STERLING NATURAL RESOURCE CENTER

Final Environmental Impact Report
SCH # 2015101058

Prepared for
San Bernardino Valley Municipal Water
District

March 2016

Figure 7
 Daily Inflow to Prado: 2071 Conditions

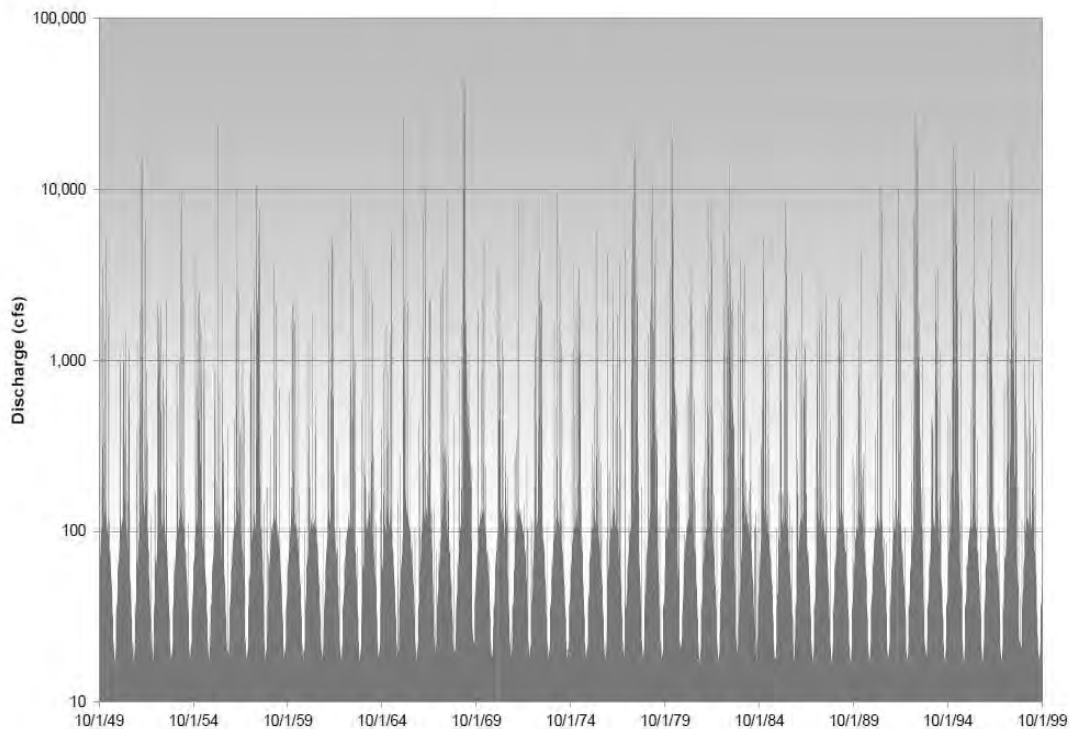
The significance of the WEI January 24, 2014 model report is that it illustrates how low surface water flow into Prado Basin is estimated to decrease in the future. As shown in the figure below, identified as Figure 7 in the WEI model report, the estimated summer-time flow into Prado Basin is in the range of 15 to 18 cubic feet per second (cfs). This value includes the total inflow to Prado Basin, including from the Santa Ana River, Chino Creek, Mill Creek, and Temescal Creek. In this estimated condition, the minimum baseflow requirements for the 1969 Santa Ana River Judgment are satisfied, but the summer-time flow rate is likely too low to support riparian habitat in Prado Basin.

For illustrative purposes, if it is assumed the water demand of riparian habitat in Prado Basin is 4.11 acre feet per acre per year and this water demand occurs during the warmest six months of the year, then the monthly water demand in the warmest six months is 0.685 feet per month (per unit area). Assuming there are 6,000 acres of riparian habitat in Prado Basin, then during the warmest six months the total water demand is 4,110 acre feet per month. If the inflow to Prado Basin is 15 cubic feet per second, within the range estimated in the WEI report (as shown in the figure below), then the estimated surface flow into Prado Basin is 894 acre feet (assuming 30 days per month). The value of the water demand of 4,110 acre feet per month is much greater than the surface inflow of 894 acre feet per month. While some of the deficit could be made up by shallow groundwater, shallow depth to groundwater is maintained to some degree by surface inflow (see Attachment 1). Additionally, there are on-going management activities in the Chino Basin that can affect groundwater levels in Prado Basin (see Attachment 1). Suffice to say, this example demonstrates the potential for insufficient quantities of water to sustain riparian habitat during the warmest parts of the year.

Sterling Natural Resource Center . 150005
Figure 11-3
 City Creek Proposed Discharge

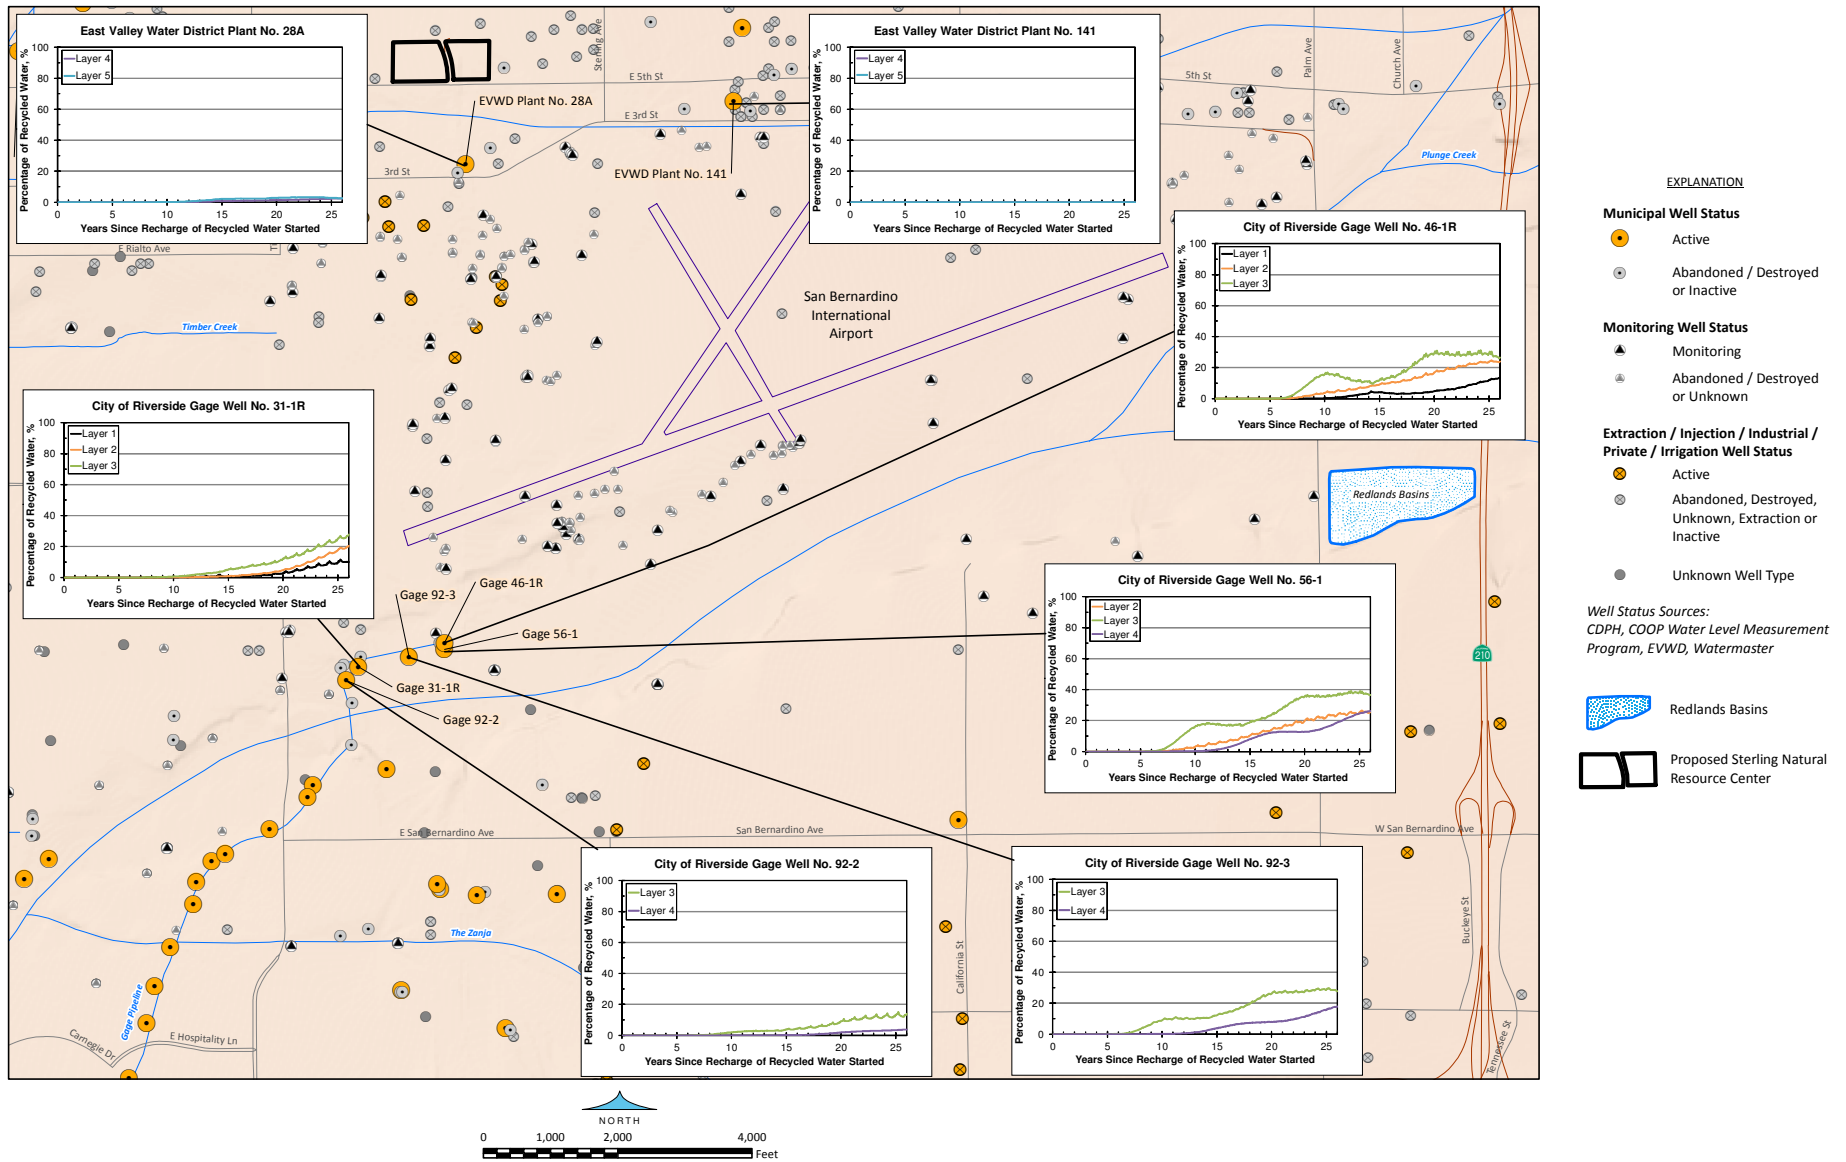
As expressed in our NOP comment letter, RPU owns 16 Gage Canal Company wells in the Bunker Hill Basin which are used for potable supply. The most northeastern Gage wells are 46-1R and 56-1, which are located approximately 3 miles downstream of the Redlands ponds and 2 miles downstream of City Creek's confluence with the Santa Ana River. RPU is concerned that the proposed project could have an adverse impact to our wells and in our NOP comment letter, requested that a study be completed to demonstrate to RPU and the Division of Drinking Water (DDW) that no adverse impacts would occur. No such study has been presented to RPU and our concerns remain the same.

The comment states there should be a study to determine if any adverse impacts will occur to RPU's groundwater wells. The comment states that in the event the analysis is flawed and an impact was to occur, RPU would expect Valley District to discontinue discharging until the problem was resolved.

The modeling results prepared by Geoscience Support Services Inc. (GSSI) (Appendix I) show there is no impact to the Gage wells from a discharge into City Creek, as shown in Figure 11-3 below. The blue lines are “particle tracks” that represent recycled water flows in the groundwater system that would result from a 10-MGD discharge to City Creek. The figure shows that after 12 months, recycled water particles have traveled less than 2,000 feet west within the groundwater basin. DDW approval of the proposed groundwater recharge activities will require that no adverse impacts occur to any nearby drinking water wells.

Figure 1-2
Bunker Hill Groundwater Basin

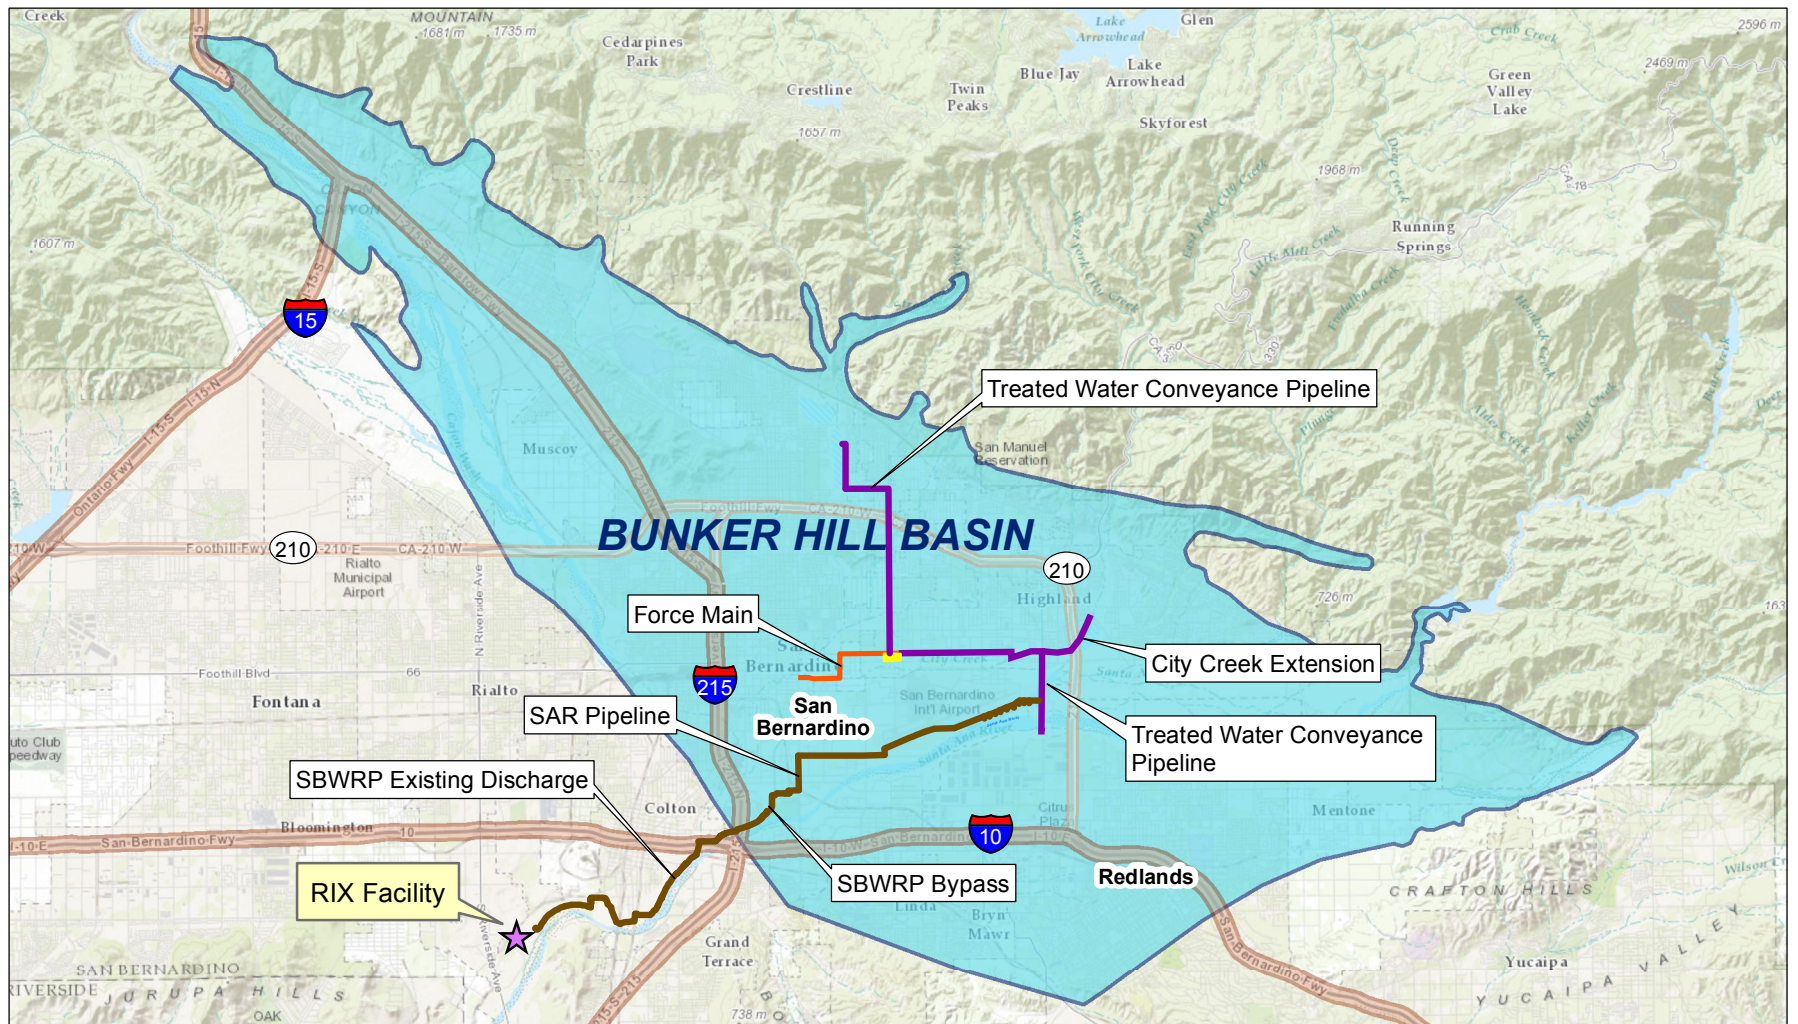
- Figure 1-2 (Page 1-5) does not provide a legend for the lines on the map. 5
2. Project Description
- Figure 2-1 (Page 2-2): The location of Rialto well pumps are not shown. 6

The comment states that Figure 1-2 on Page 1-5 does not provide a legend for the lines on the map.

In response to the comment, a legend has been added to Figure 1-2. The figure is reproduced in Chapter 12: Clarifications and Modifications.

1-5	<p>Figure 1-2 was revised to include labels that identified the proposed project components.</p>

Figure 2-5
Treated Water Conveyance System Pipelines

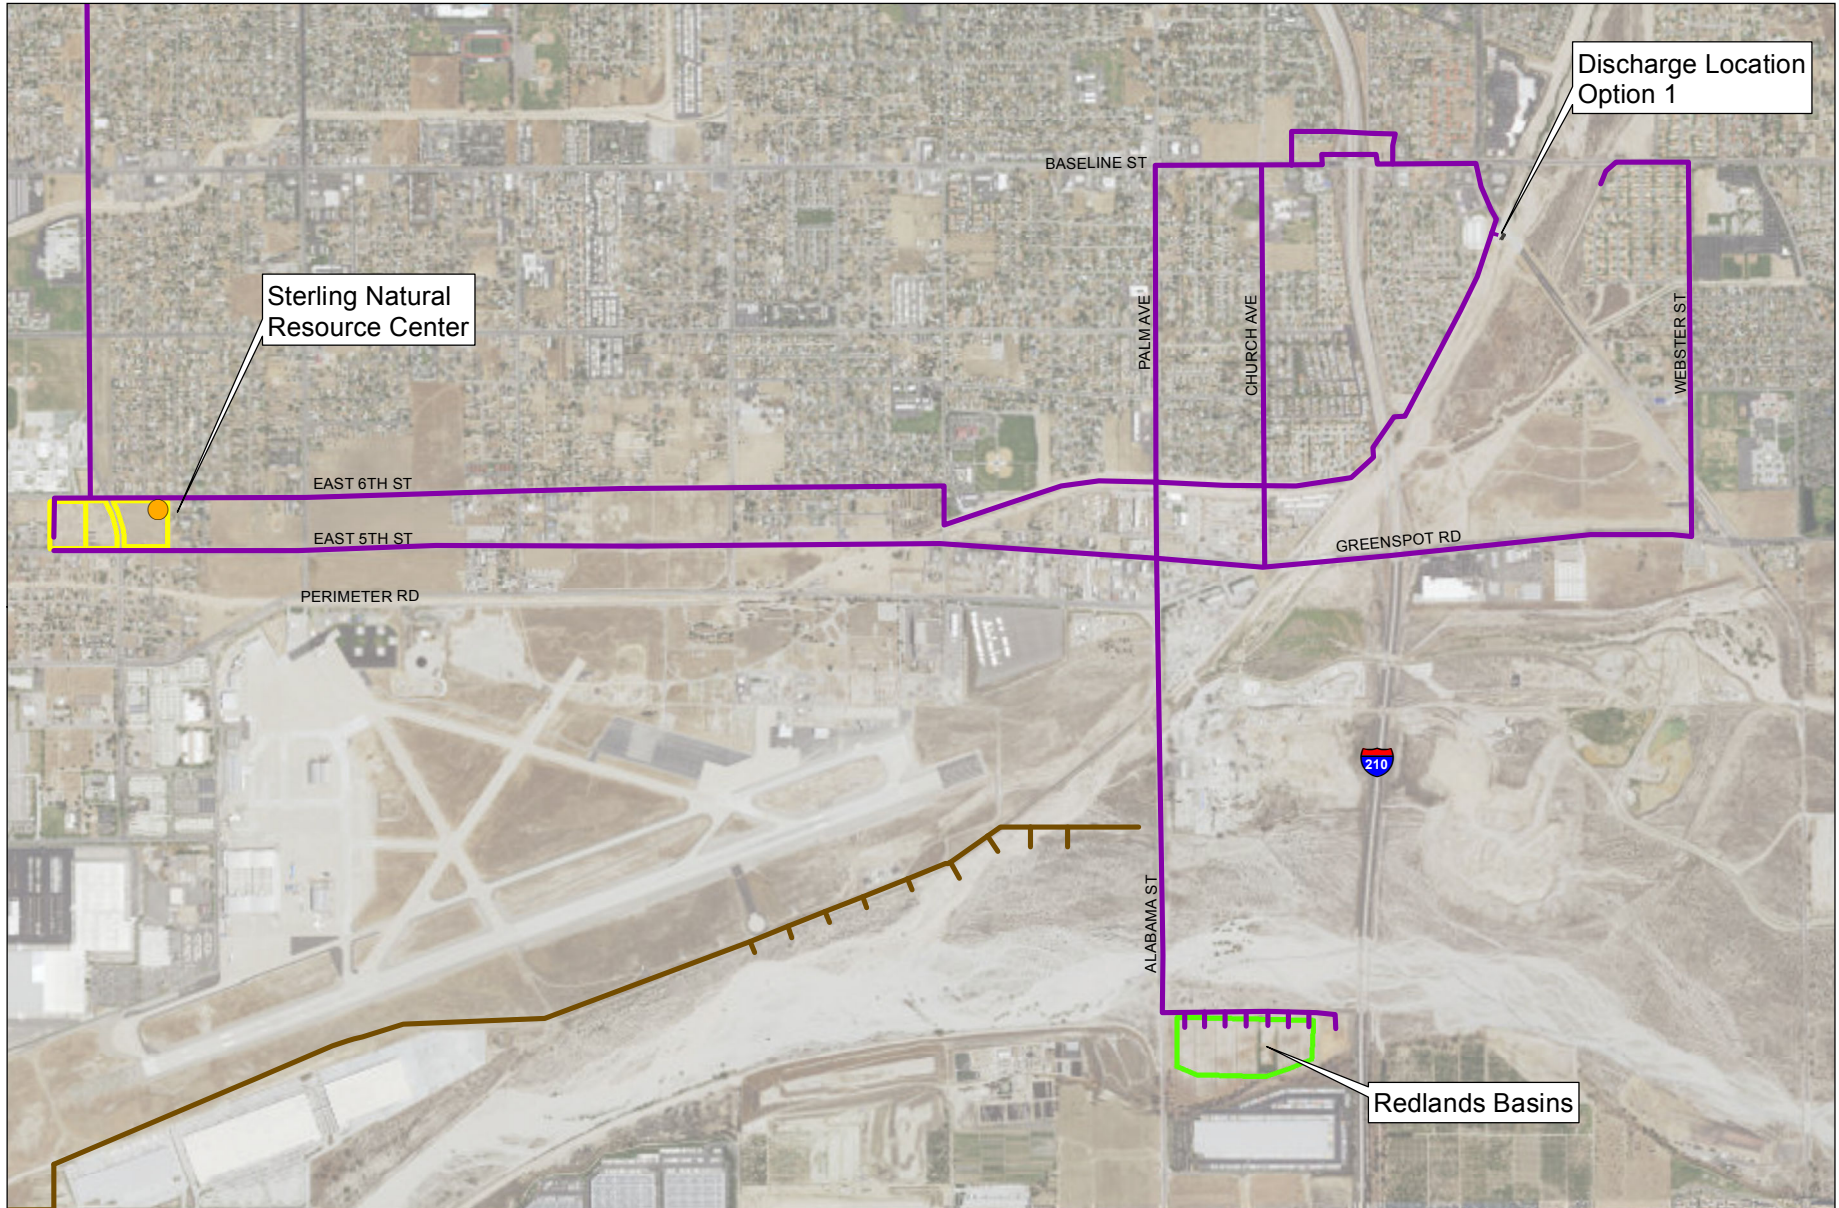
The text of the DEIR describes different alignments of Treated Water Conveyance System pipelines to City Creek and Figure 2-5 includes a proposed pipeline that traverses City Creek at 5th/Greenspot road and continues east to some undisclosed terminus. We could not locate a description of this pipeline or an impact evaluation of it.

The Figure 2-5 has been modified to show that the treated water conveyance alternative would traverse City Creek in order to discharge to the creek from the eastern edge. The revised Figure 2-5 is included in Chapter 12.

2-16 Figure 2-5 did not show the entire route of the proposed City Creek pipeline and the proposed discharge structure location. It has been modified to show that the treated water conveyance alternative would traverse City Creek in order to discharge to the creek from the eastern edge.

Figure 3.4-2
Critical Habitat

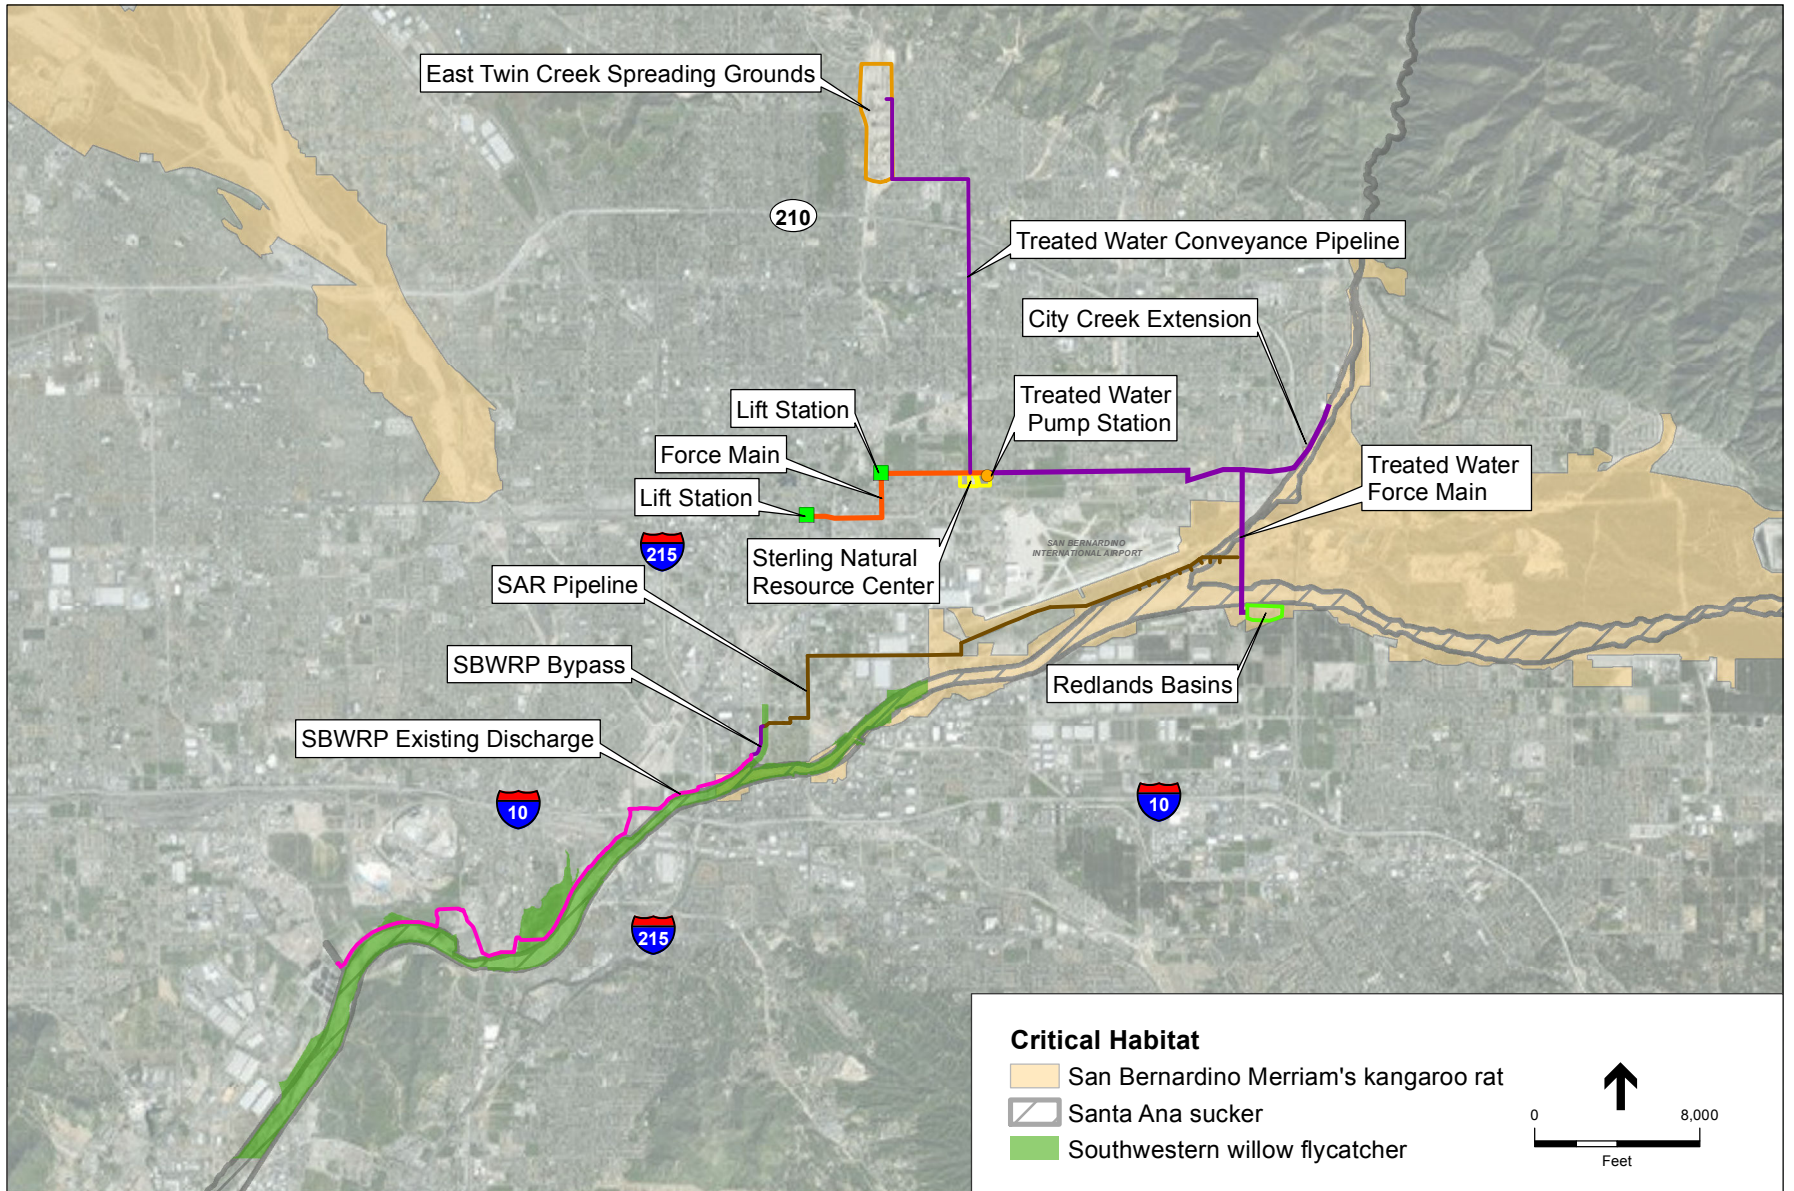
The DEIR anticipates a three percent reduction in wetted area due to a 6 MGD reduction in flow, and that this change will have a less than significant effect to the riparian plant community. Regional groundwater management has increased in recent years. In order to analyze cumulative effects to the riparian plant community, a regional assessment is needed to determine the baseline from which you can assess project impacts. Please include in the FEIR a regional groundwater basin assessment for City Creek and the Santa Ana River in the assessment of potential changes to the riparian plant community from the project, as and how those changes will affect flycatcher, vireo, and their critical habitats.

Critical Habitat for this species does not occur in the areas impacted by construction of the project components. However, Figure 3.4-2 has been modified to show the proximity of Critical Habitat for southwestern willow flycatcher within the segment of the SAR downstream of the RIX discharge. The revised Figure 3.4-2 is included in Chapter 12.

3.4-32 Figure 3.4-2 was revised to include the critical habitat of the southwestern willow flycatcher.
